CONSTRUCTION SUMMARY

Summer Ridge Estates Inc.

LOT NUMBER	PHASE	HOUSE TYPE	CLOSING DATE
020 BLOCK 291	1	FRENCH ROSE (25-04 B 4) ELEV B 4 BEDROOM	12-Nov-25

BLOCK 291 - TH. 20 25-04 END FRENCH ROSE EL. B 4 BEDROOM 2385 SQ. FT.

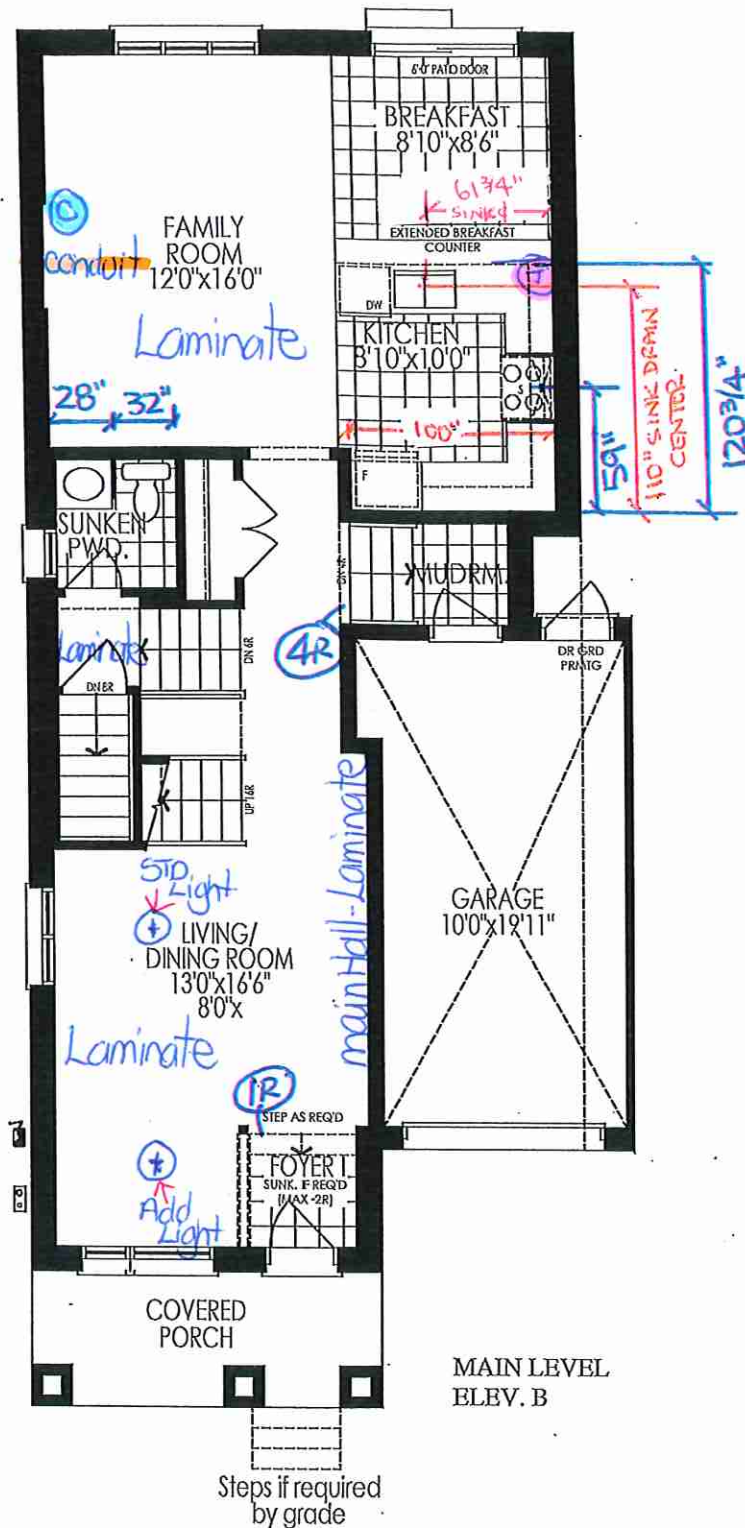
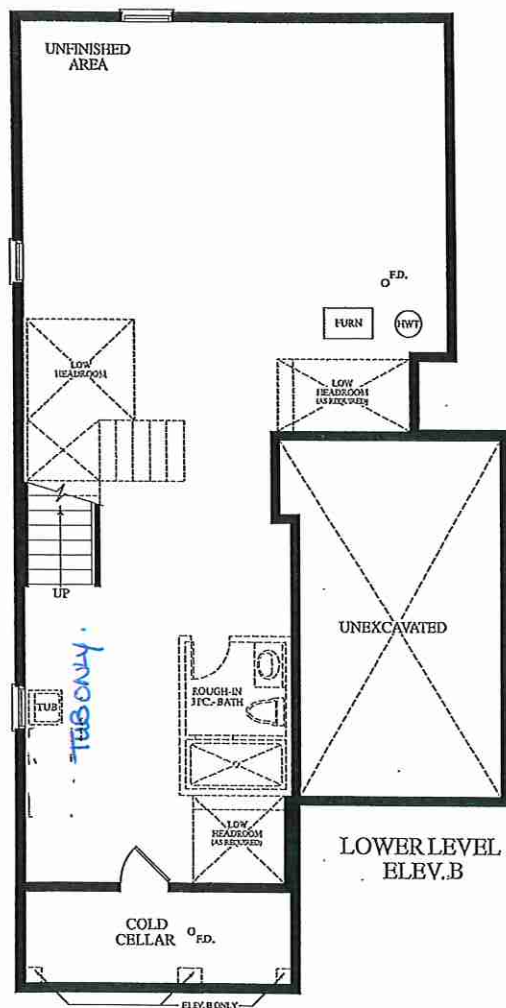
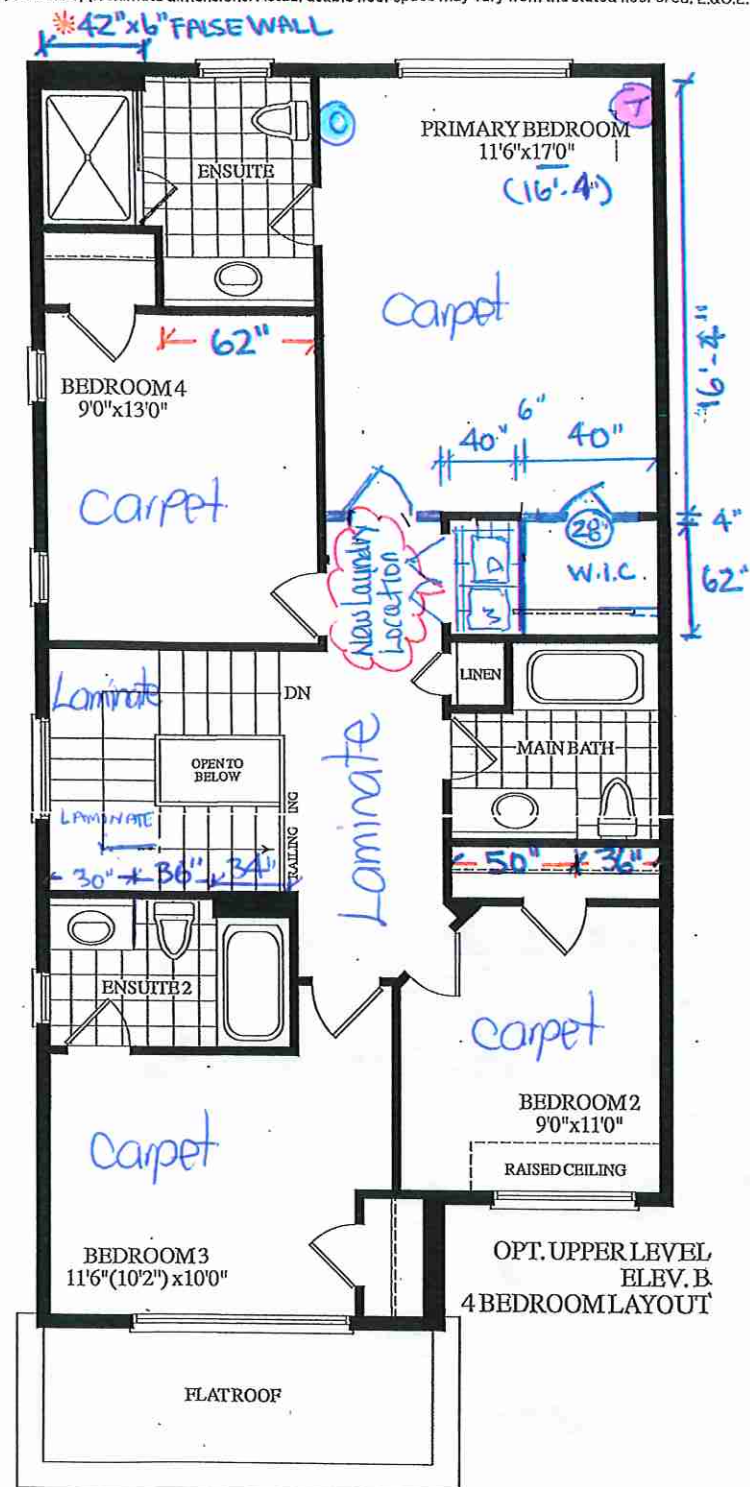
1 - Refer to attached schedule "G". Purchaser accepts and acknowledges the deletion of the Mud Room closet to accomodate the door from the garage.
Note:

1 - PRIMARY BEDROOM- Shift the Primary Bedroom entrance towards the bedroom, making it in line with the Primary Bedroom Walk In Closet (See Sketch)
Note: **Priced as per Steve C

1 - PRIMARY BEDROOM WALK IN CLOSET- Decrease the primary bedroom walk in closet to accommodate for a Laundry room (See Sketch)
Note: To include builders standard double doors
This item is included in price above as per Steve C

1 - SECOND FLOOR LAUNDRY ROOM-Relocate the laundry Rough In ONLY for a side by side washer & dryer from the basement to the Upper hall. To be installed between the primary bedroom & Linen Closet. (See sketch)
Note: To Include: builders standard floor tile, drain, fan,standard double doors,standard ceiling light & switch , washer and dryer as per standard package
**This item is included in price above
Builders standard sink to remain in the basement **No rough in for a sink
